Submission re: MOD2019/0378 - DA2018/0880 - 49 Lauderdale Avenue, Subject:

Fairlight

#### Re: MOD2019/0378 - DA2018/0880 - 49 Lauderdale Avenue, Fairlight

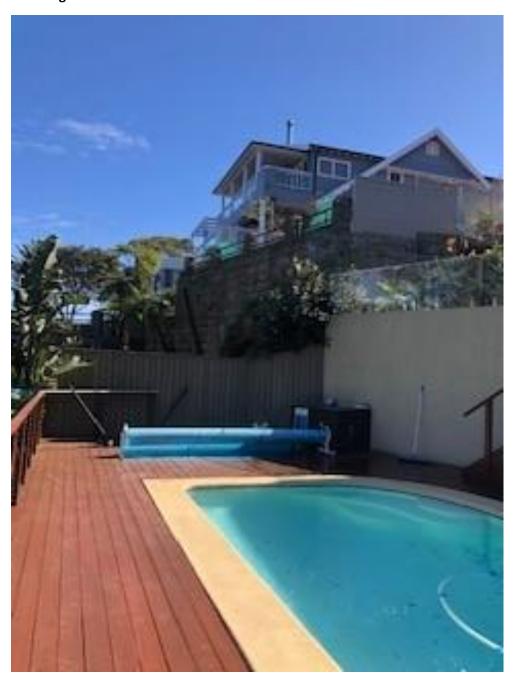
- Both balconies directly overlook our pool from above thus issues with privacy for us and others. The privacy screens do not address this. See picture 1.

Picture 3 - retaining wall – looking to west from 45 – showing bulging and also where ground level of 45 is

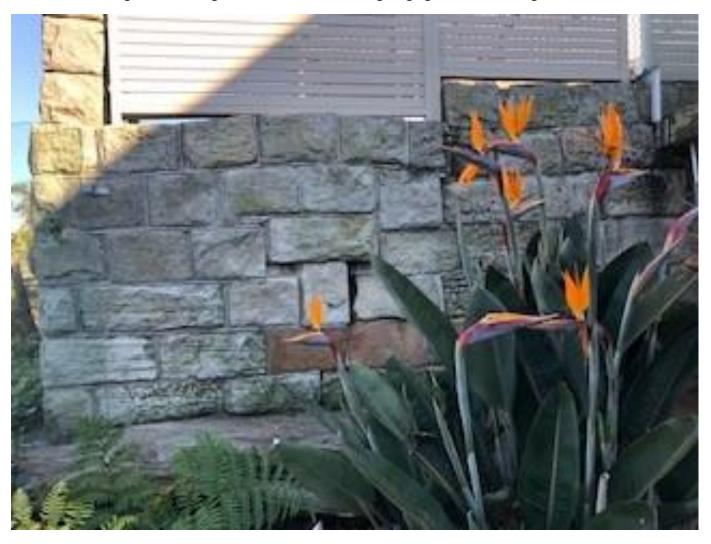
- Concerns over the ability of the retaining wall to hold the build, now the fig tree has been removed the Geotech report was done on the basis of the approved DA, not with the proposed amendments. See pictures 2 and 3.
